**CHEMKA POOL STORM DAMAGE RECOVERY  
HASTINGS-ON-HUDSON**

**ADDENDUM NO. 2 – July 5, 2022**

drawing title:  
**ELECTRICAL**  
**BATHHOUSE DEMOLITION PLAN, POWER AND LIGHTING PLANS**

**E-1 of 5**

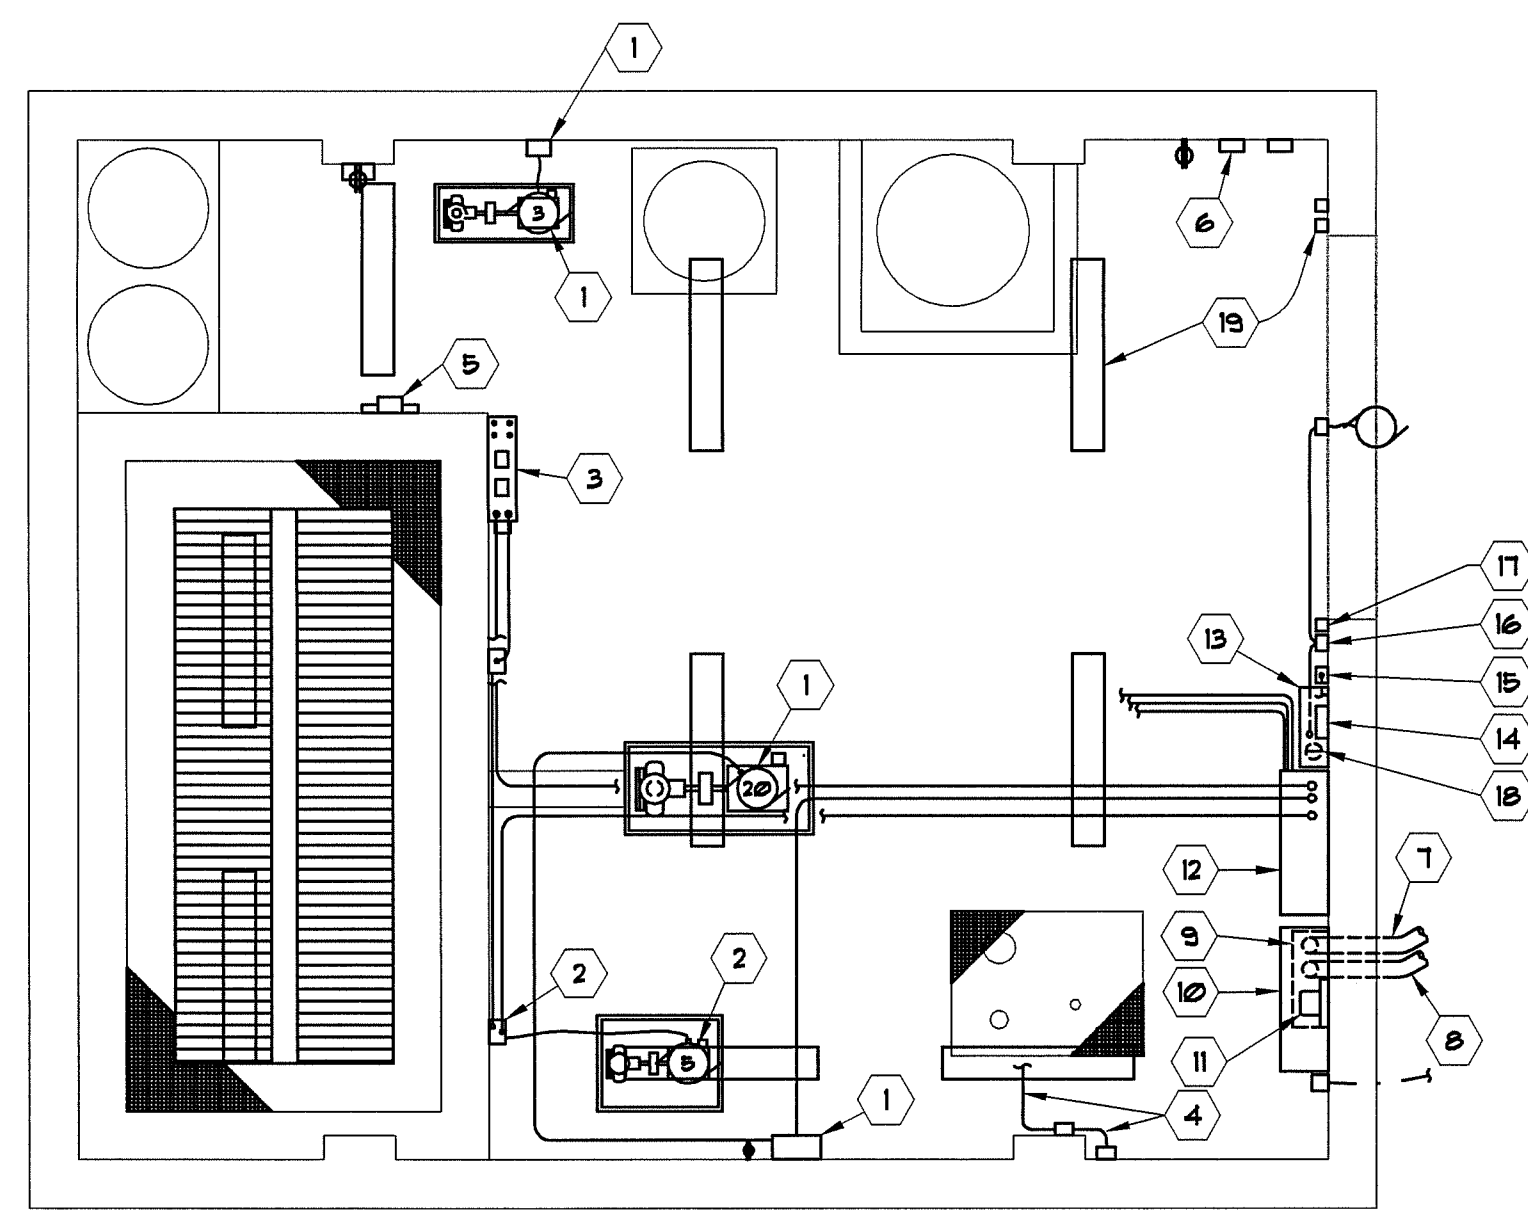
- E. Contract Drawing E-02
  - a. Demolition Note No. 6 shall be replaced with new Demolition Note No.6 to read as follows:

“ The electrical contractor shall disconnect and remove the wiring and conduit between the existing ceiling mounted pullbox and existing panels OLP and LP (see Reference Drawing E-1 of 5.

The contractor shall maintain enough slack in the existing wiring to extend the circuits, described in 4 above, using a new pullbox as shown on New Contract Drawing E-02 with new wiring to new Panels OLP and LP as shown on new Contract Drawings E-02 and E-03.

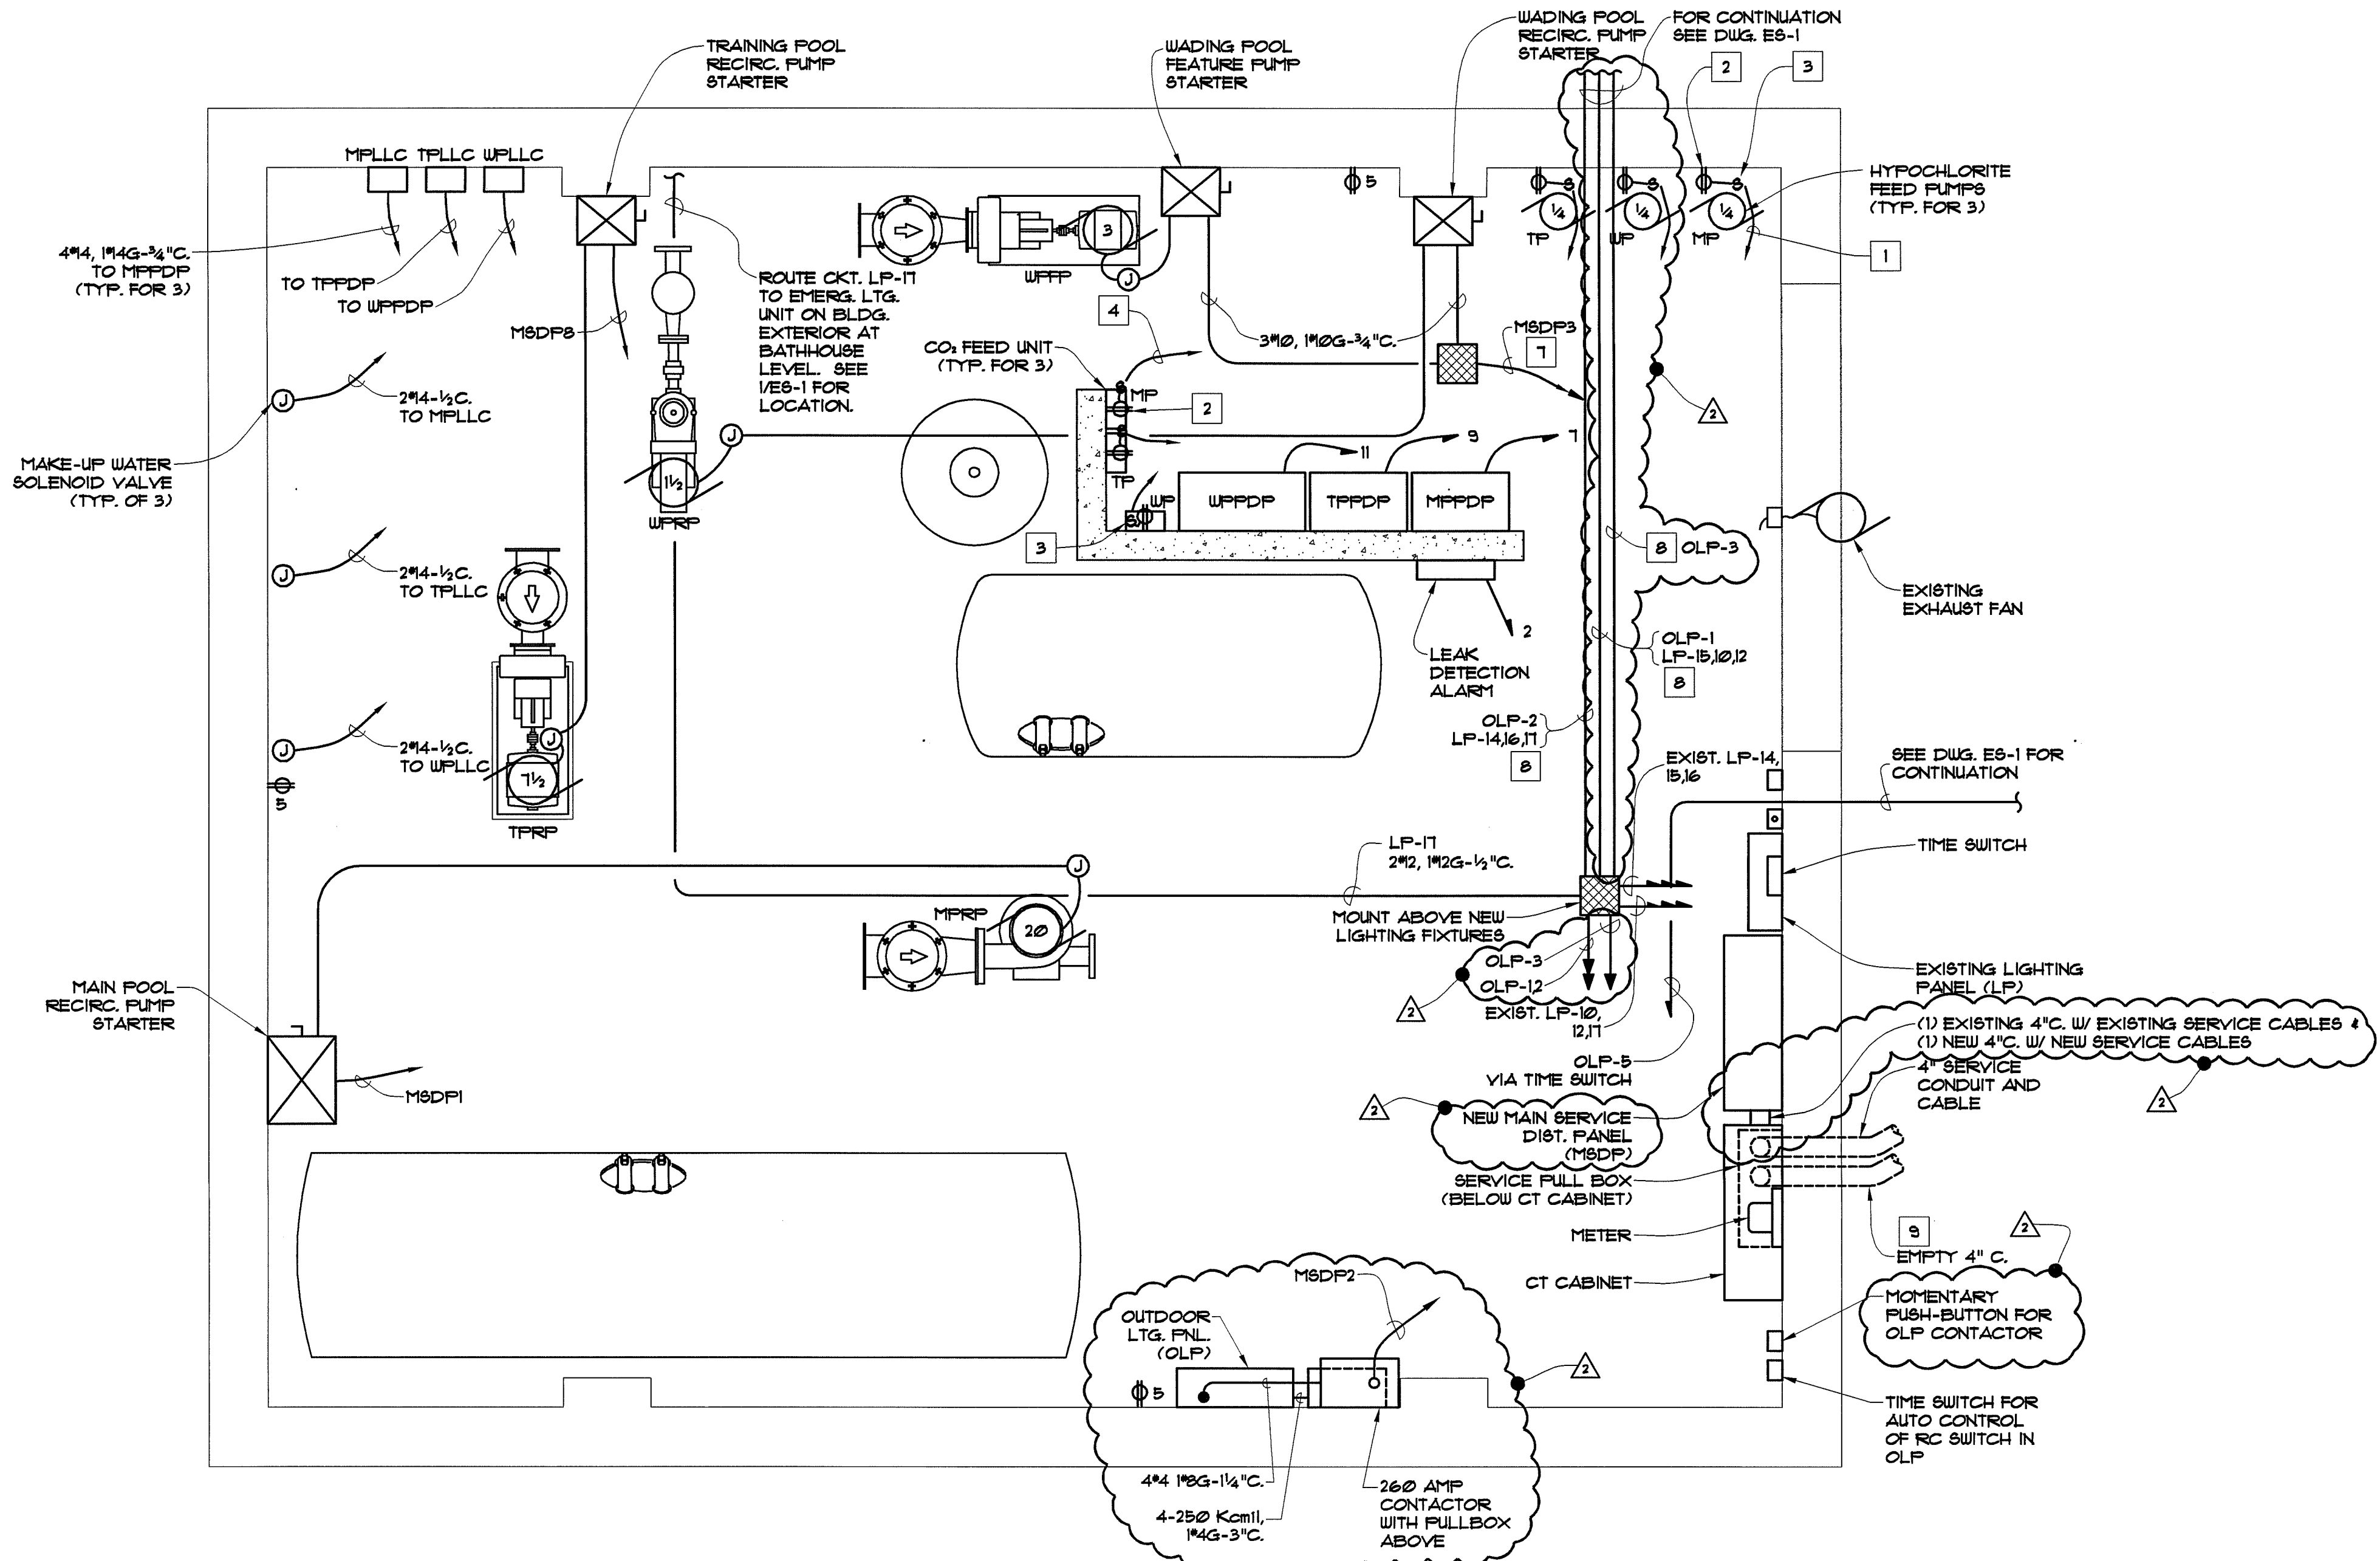
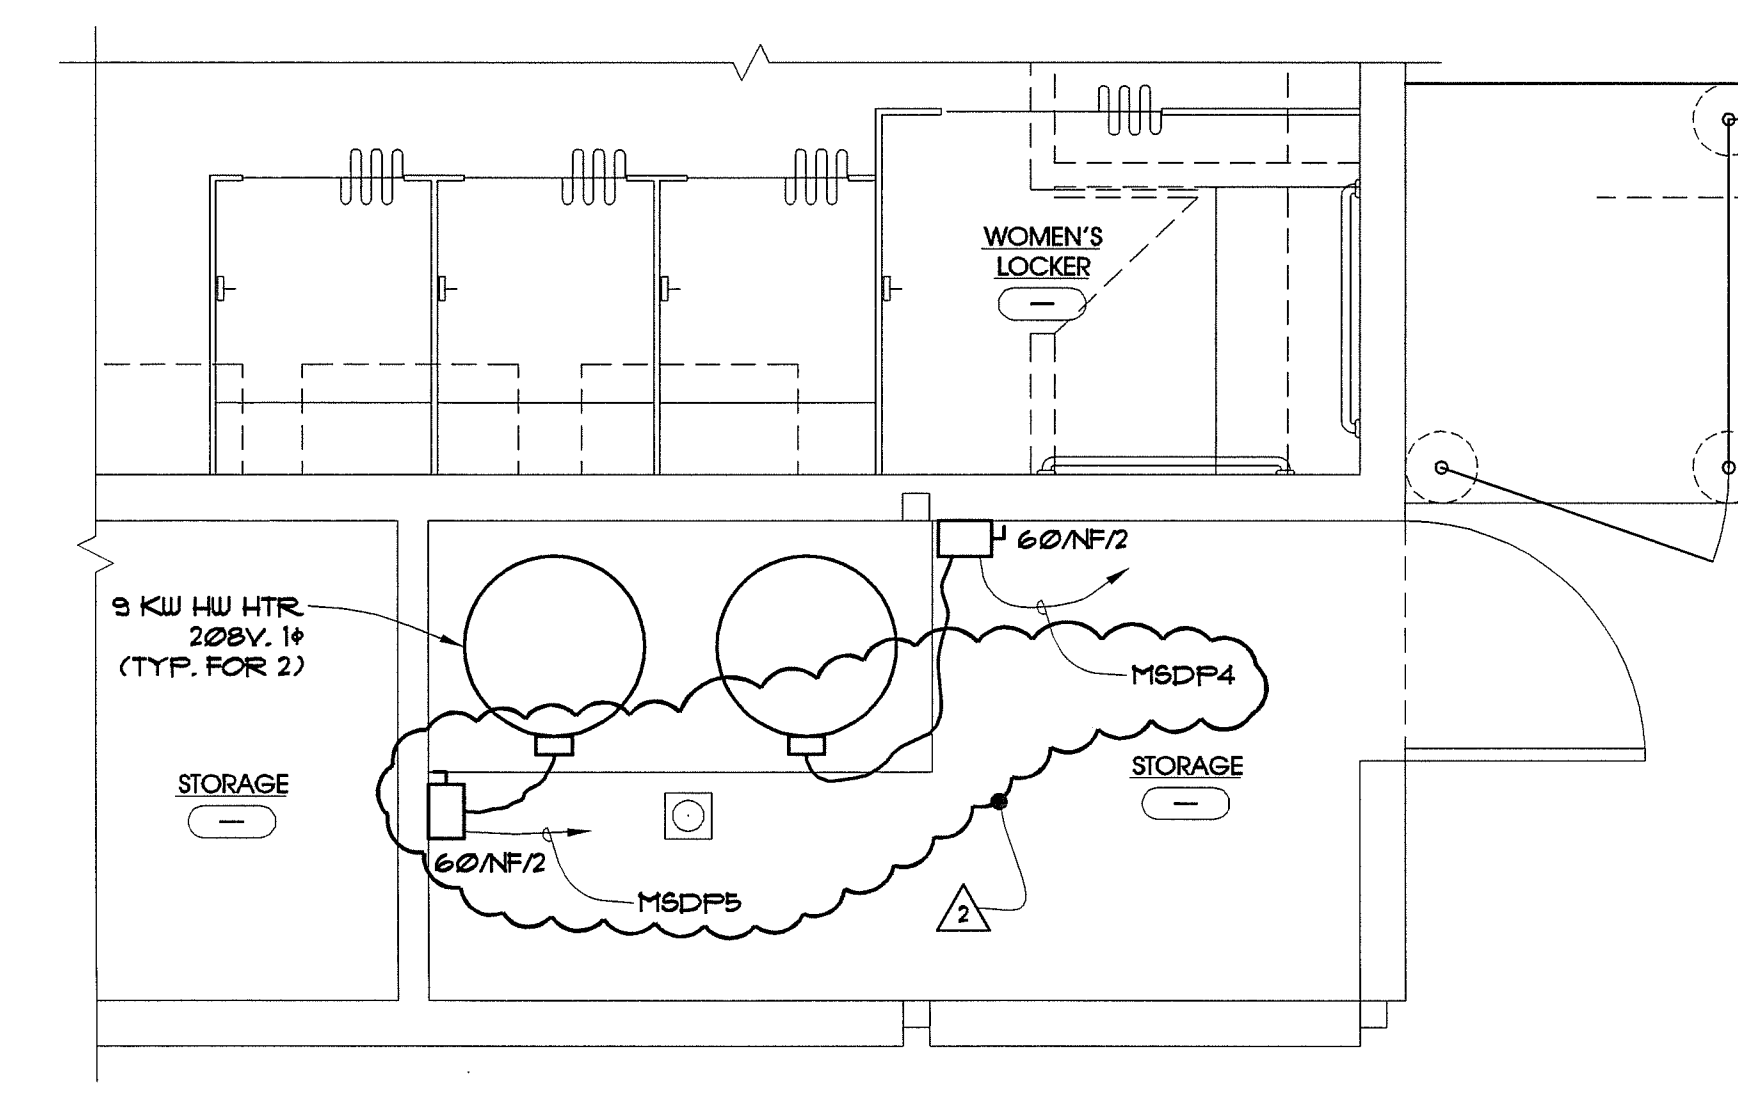
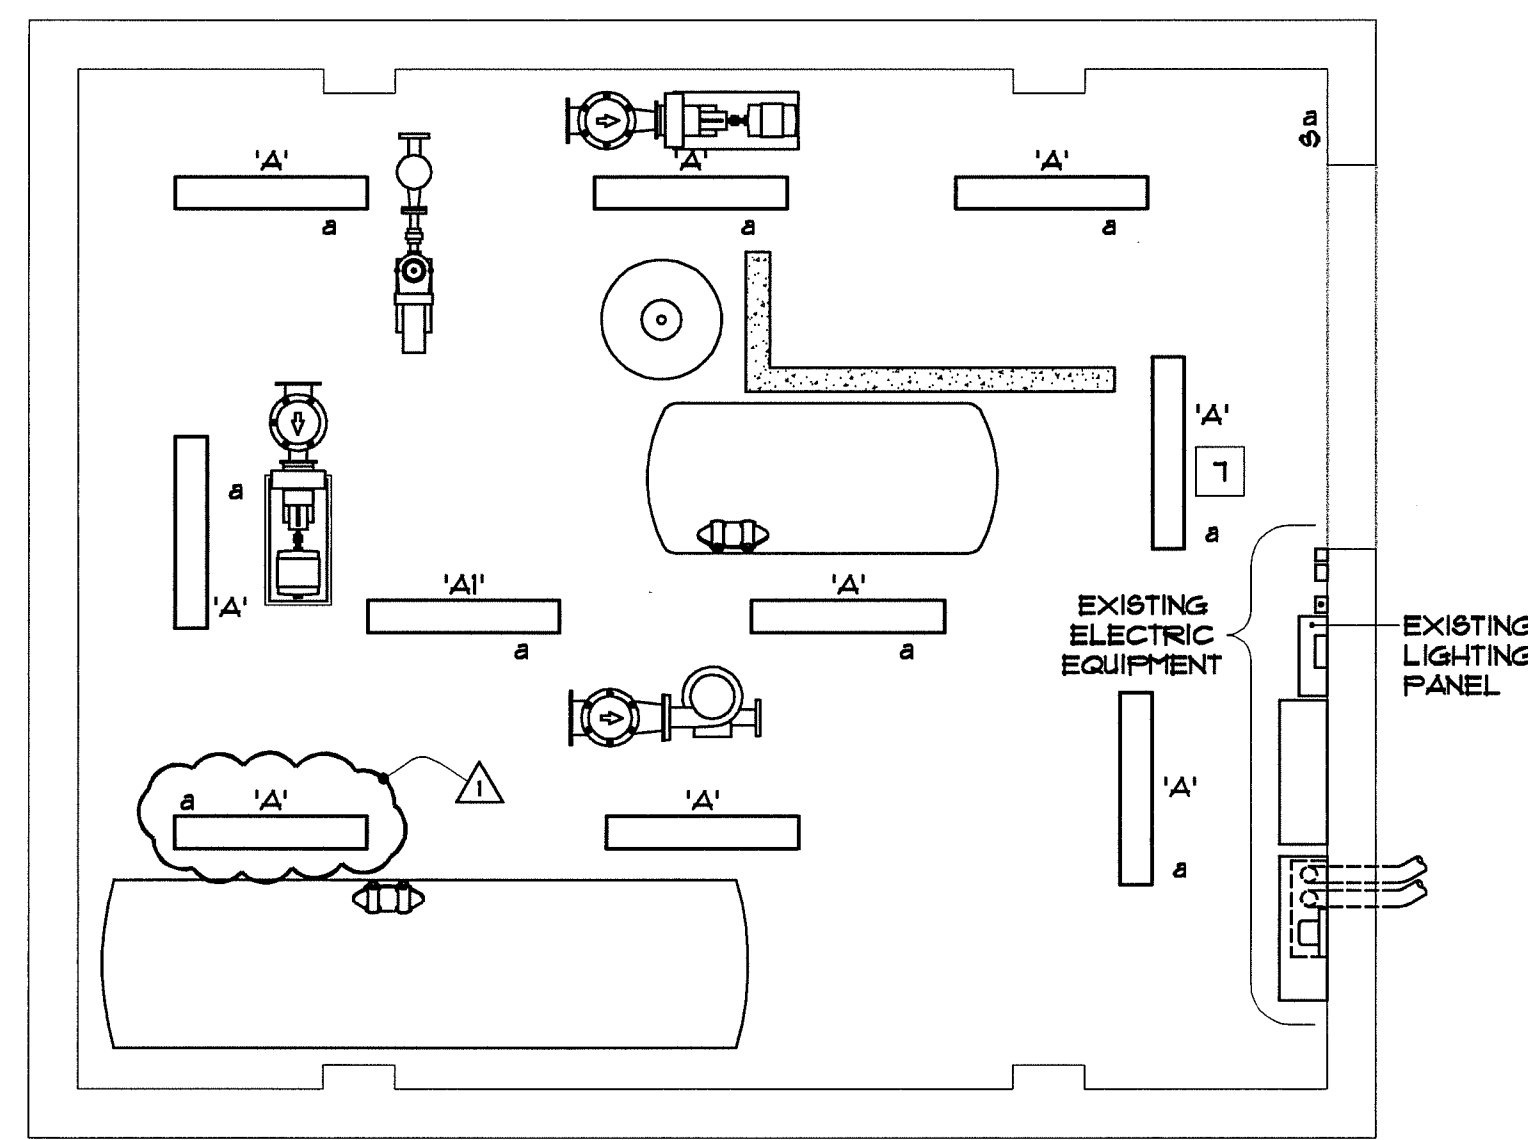
- A. On record Reference Drawing ES-1 of 2, Electrical Site Plan, Power and Lighting, an 11”x 18” x 12” DP pullbox is shown on the SITE PLAN-POWER AND LIGHTING plan on the deck on the north side of the Bathhouse. This pullbox is also shown on Contract Drawing E-02.

- B. Subsequent site surveys have not located this pullbox and it is assumed that the circuits serving the outdoor lighting and receptacles are run directly from the Filter Room panels to the exterior lighting and receptacles via an existing pullbox in the Filter Room.

- C. Add Reference Drawing E-1 of 5, Electrical-BATHHOUSE DEMOLITION PLAN, POWER AND LIGHTING PLANS to the drawing set.
- D. The contractor shall trace the existing circuits in the existing conduits which exit the Filter Room on the north wall and identify them as follows:

- 1. Circuit OLP-1, Light Tower P2
  - 2. Circuit OLP-2, Light Tower P1
  - 3. Circuit OLP-3, Light Tower P1
  - 4. Circuit LP-10, Convenience Receptacles (All Pools)

- 5. Circuit LP-12, Vacuum Cleaning Receptacle (Wading Pool)
  - 6. Circuit LP-14, Vacuum Cleaning Receptacle (Training Pool)
  - 7. Circuit LP-15, Vacuum Cleaning Receptacle (Main Pool)

- 8. Circuit LP-16, Vacuum Cleaning Receptacle (Training Pool)
  - 9. Circuit LP-17, Outdoor Emergency Lighting

These circuits shall be extended to new Panels OLP and LP as shown on new Contract Drawings E-02 and E-03 and as described in Ea below.
